# An Bord Pleanála Opinion Response Report (Architectural Items)

**THE FARM**  
BESSBOROUGH  
BLACKROCK  
CORK

**MARCH 2022**

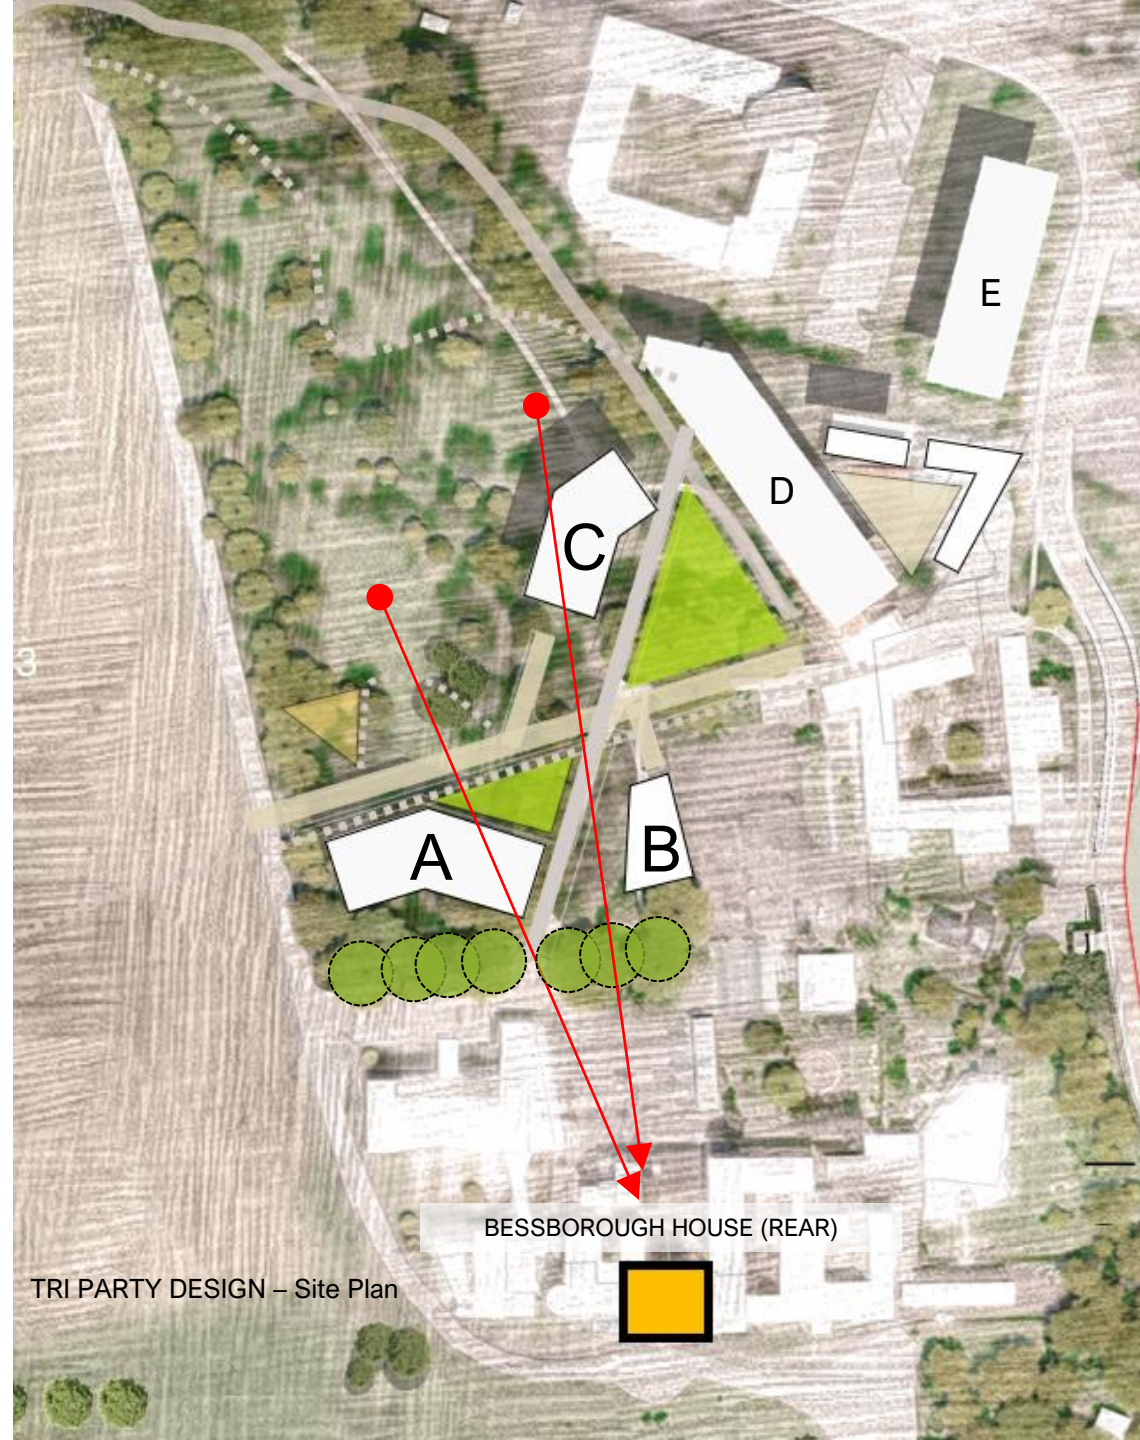
- (i) The potential impact of the development on the relationship and connection between Bessborough House, a protected structure, and its parkland / demesne setting. Regard should be had to the concerns expressed by the PA in their submission to An Bord Pleanála dated 08/10/2021 with regard to the siting of Blocks A, B and C in this regard.*
- (ii) Any works proposed to, or impacts on, the entrance avenue and the original entrance gateway to Bessborough House, including the limestone piers and cast-iron railings and gates.*

ITEM 2.(i) With regard to this specific item , we assume is in response to an extensive discussion around the location of 3 Buildings ( A, B & C as titled at this stage ) located with in the Parkland setting to the North of Bessborough House at Tri- Party submission. Concern was raised by CCC around the potential impacts on visual and physical connection to The main residence. Of note particular direction was given from the City Architect in how the issue may be resolved which the Design team has followed directly in its redesign per the application.

The principle concern expressed by CCC was the potential for the loss of visual connection from the Northern Park to Bessborough House itself which we question given the tallest trees onsite bounding the Southern boundary. This said given the sensitive nature of the site and in particular the clear direction from the City Architect in resolving the design issue , Buildings A is removed and buildings B & A are relocated to the boundary similar to the design approach of D in the Farm.

## CITY ARCHITECTS DIRECTION

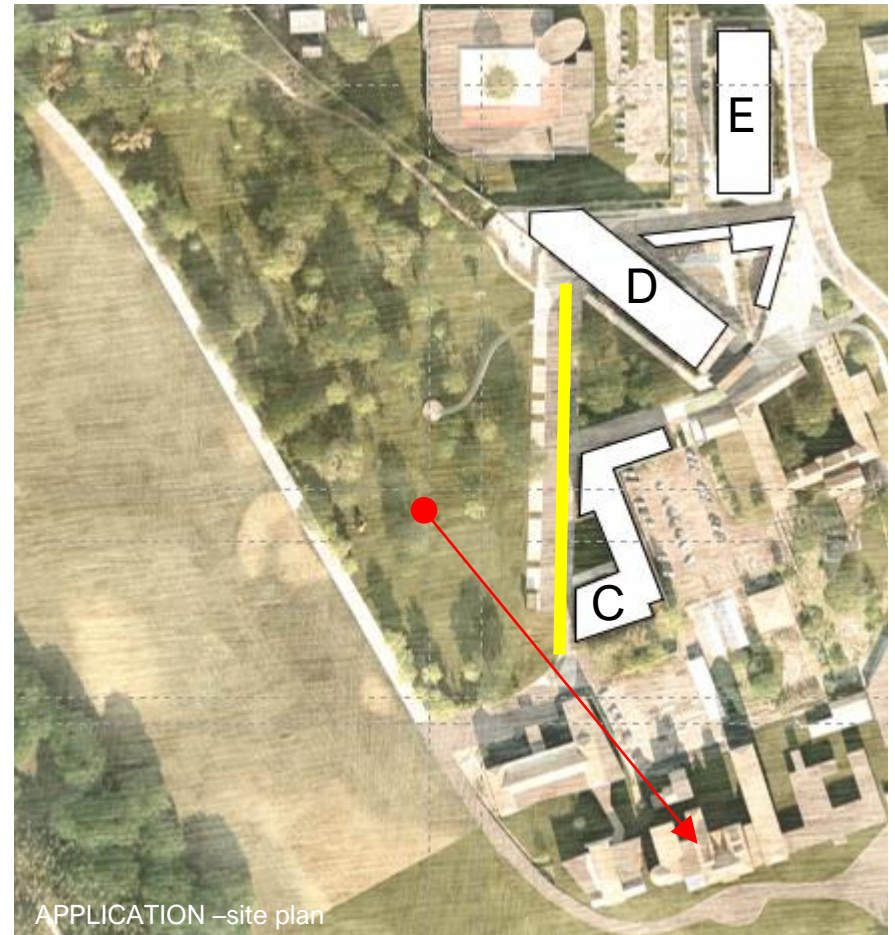
'...The original Bessborough House and Estate had farm buildings and associated plots to the north-east area of the estate and the remainder of the estate was parkland. The proposed development are apartments within a park setting, four to six storeys in height and have minimal relationship to the park. Block A should be omitted, and Blocks B and C relocated and reconfigured to form an edge to this parkland in association with the farm buildings.' – City Architect.

The adjustment is incorporated in the new building C which is 'reconfigured to form an edge to this parkland' while also reducing in scale significantly to 3 storeys in height. This also supports the zoning objective by provision of the former main access from the house to be highlighted (yellow) with a clear edge to the East. Consequently with this alteration and redesign the landscape benefits are clear in the retention of the primary open space of the park setting while additionally giving an historic route more definition and clarity.

**TRI PARTY DESIGN – Site Plan**

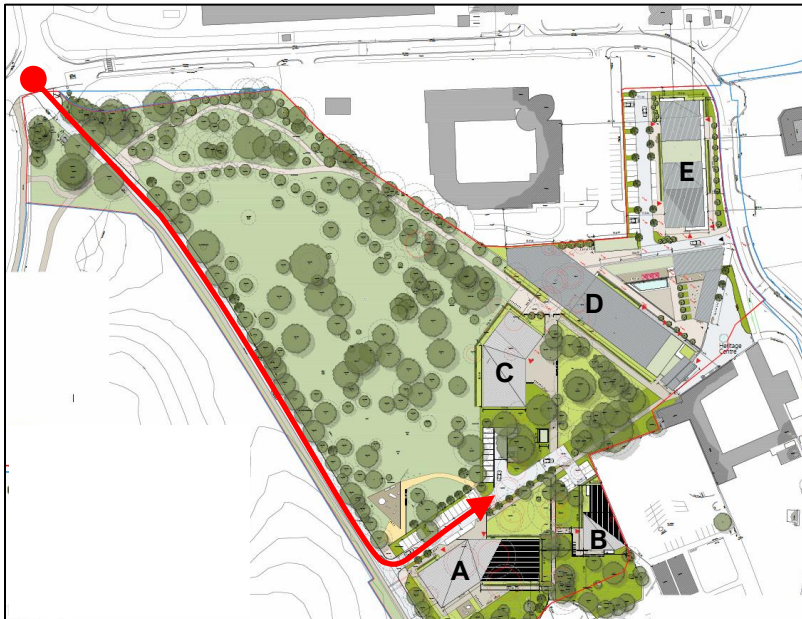
ITEM 2. (ii) Any works proposed to, or impacts on, the entrance avenue and the original entrance gateway to Bessborough House, including the limestone piers and cast-iron railings and gates.

(ii) The Tri-Party application proposed access to Buildings A B & C via the main Bessborough House entrance gates and concerns were raised as to capacity of this entrance to accommodate the new arrangement. During the redesign phase of the Parkland buildings and effectively the removal of buildings A & C , the access arrangement was also altered to enter from the East ,negating the need for any upgrades / modifications to the historic gate assembly .

**TRI PARTY DESIGN – Site Plan**

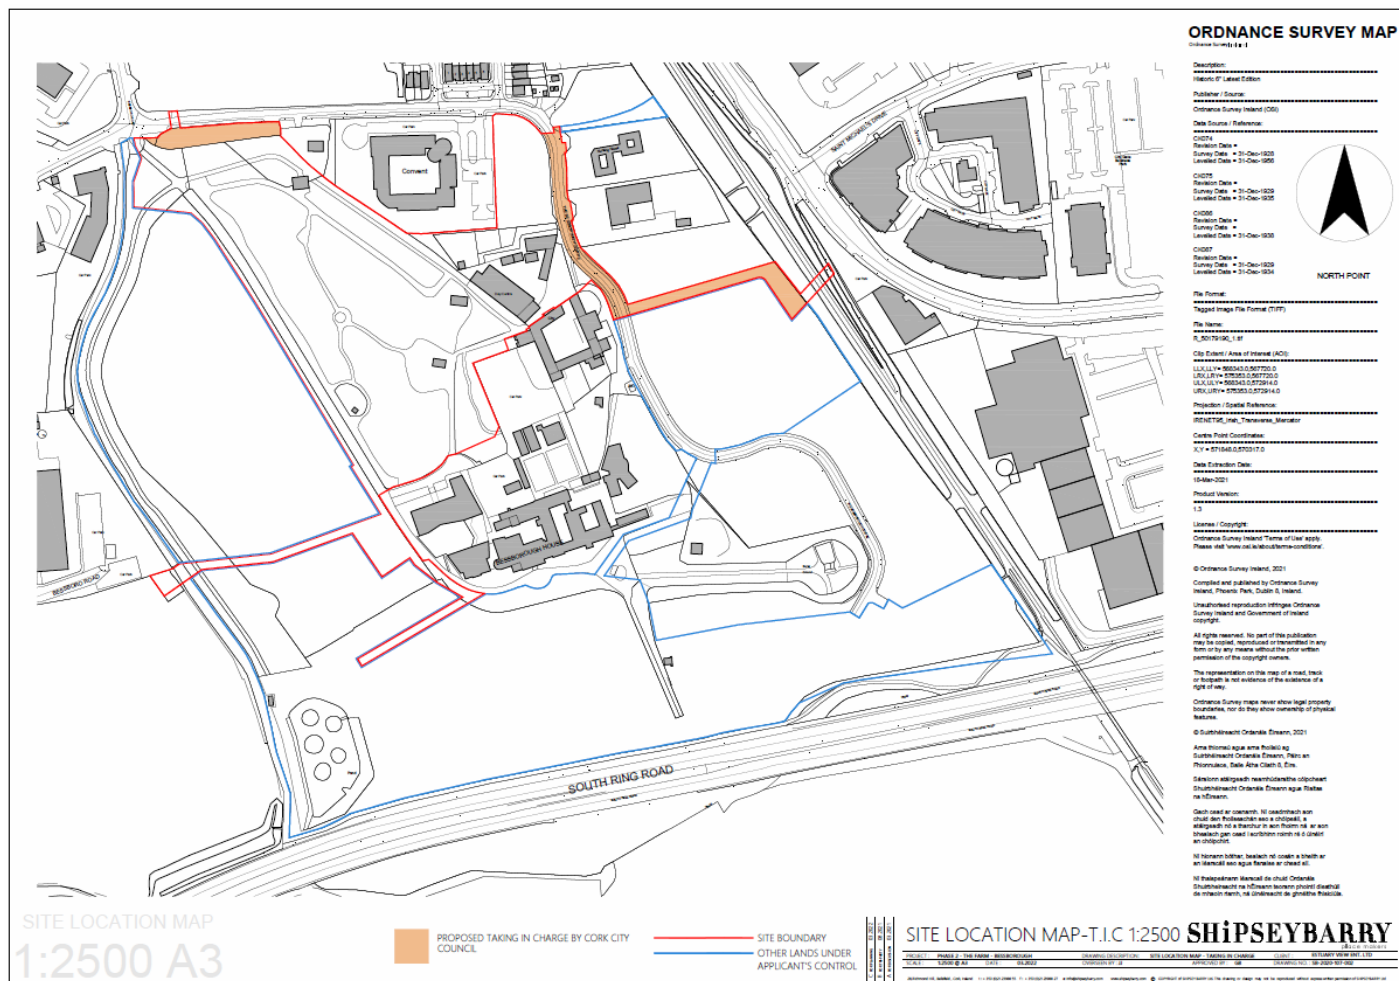
*The application should describe how a convenient and quality pedestrian and cycle connection from the proposed development to the Marina and Blackrock - Passage Greenway to the east can be delivered. The ability to achieve such connection independent of other planned development should be clearly demonstrated. The route of such connections should form part of the Quality Audit undertaken in respect of the proposed development.*

At Tri-party stage a Northern link to the Western Greenway ( scheduled for upgrade ) was proposed and was viewed by CCC as remote and a challenging practical distance to be effective . The Application proposes a much shorter route with a bridge connection to an existing down ramp to the Passage West / City Greenway which we believe is a significant improvement . All these lands are in the applicants ownership and the bridge can be delivered independently from other applications . We confirm this will be assessed in the Quality Audit undertaken

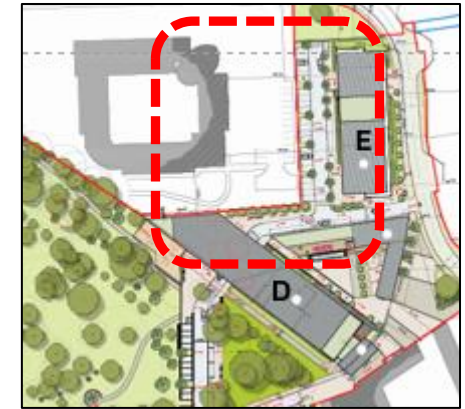
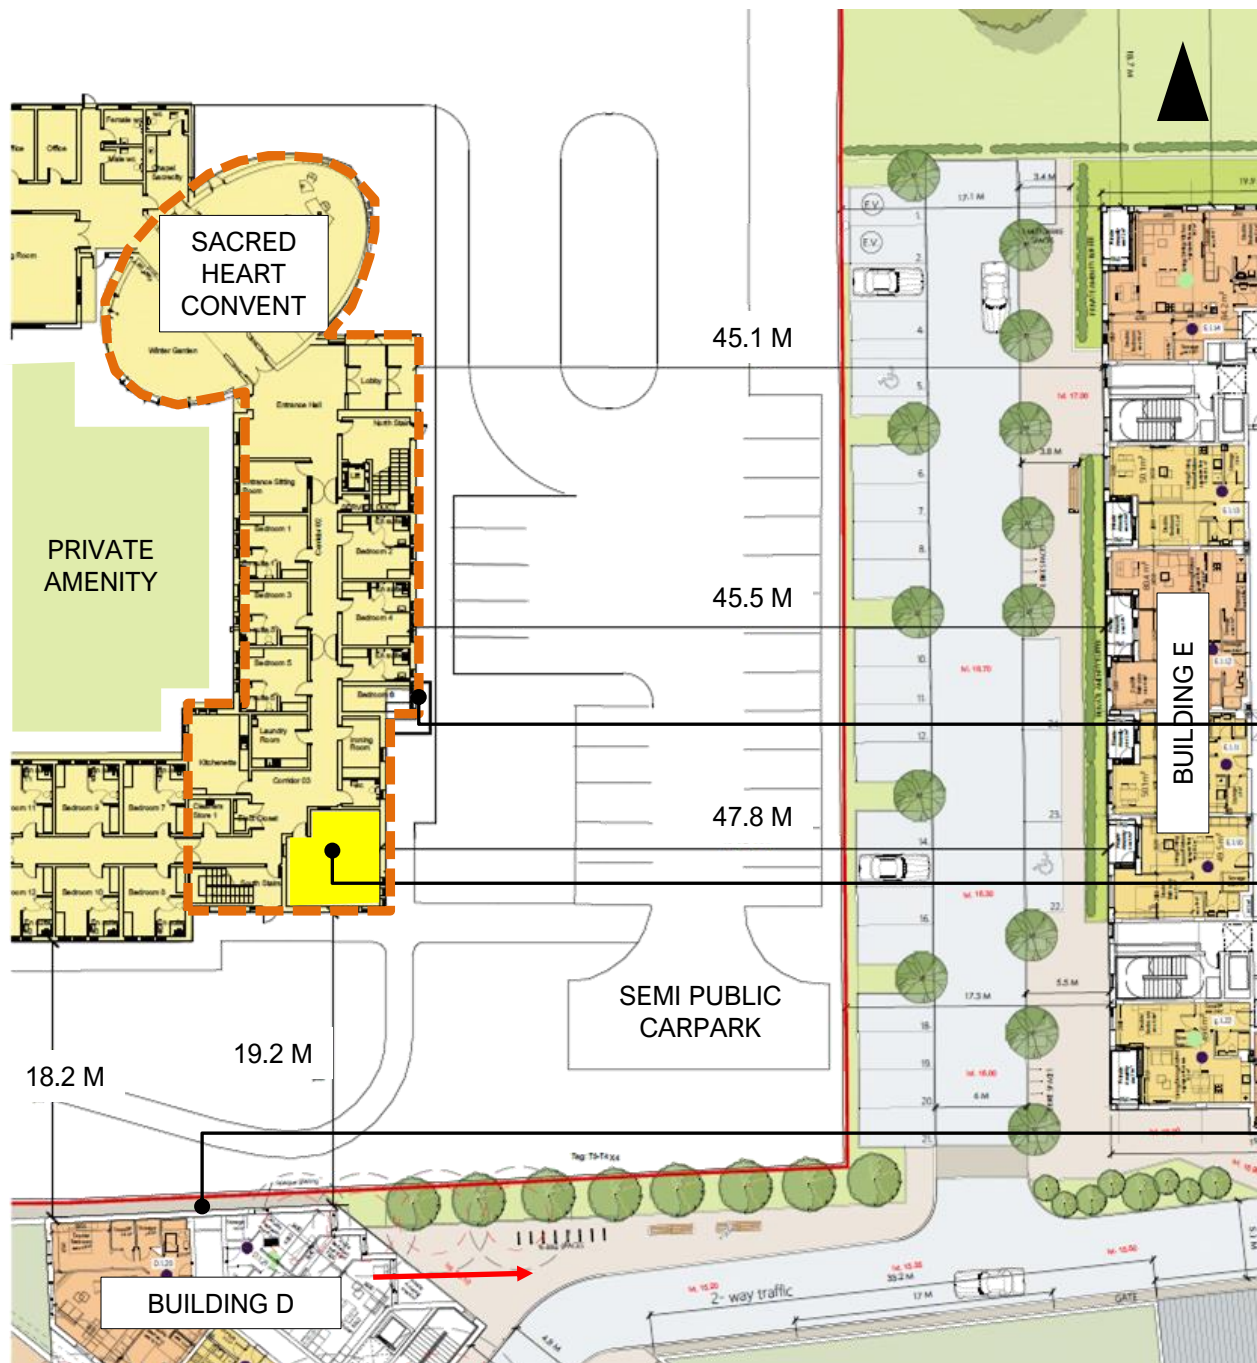
*Detail of the relationship of Buildings D and E at The Farm with adjoining lands at the Sacred Heart Convent and the potential for overlooking or impacts on the amenities thereof should be clearly described.*

The application proposal considers the Sacred Heart Convent relationship individually for each building D & E .

Building D in the closest in proximity to the Convent to the North at an 18 m face to face building relationship. For this reason the Northern end wall is predominantly blank with no overlooking form apartments . Limited glazed elements to end of corridors is are provided which are fully obscured /frosted glazing. The building meets the boundary . The building dips to 4 storeys at this boundary point .

Building E 's west facing balconies are approximately 45 m away from the building face of the convent building . Notably to the West is the applications carpark and then the Convent carpark beyond . The Convents primary amenity space is contained with in a central courtyard area
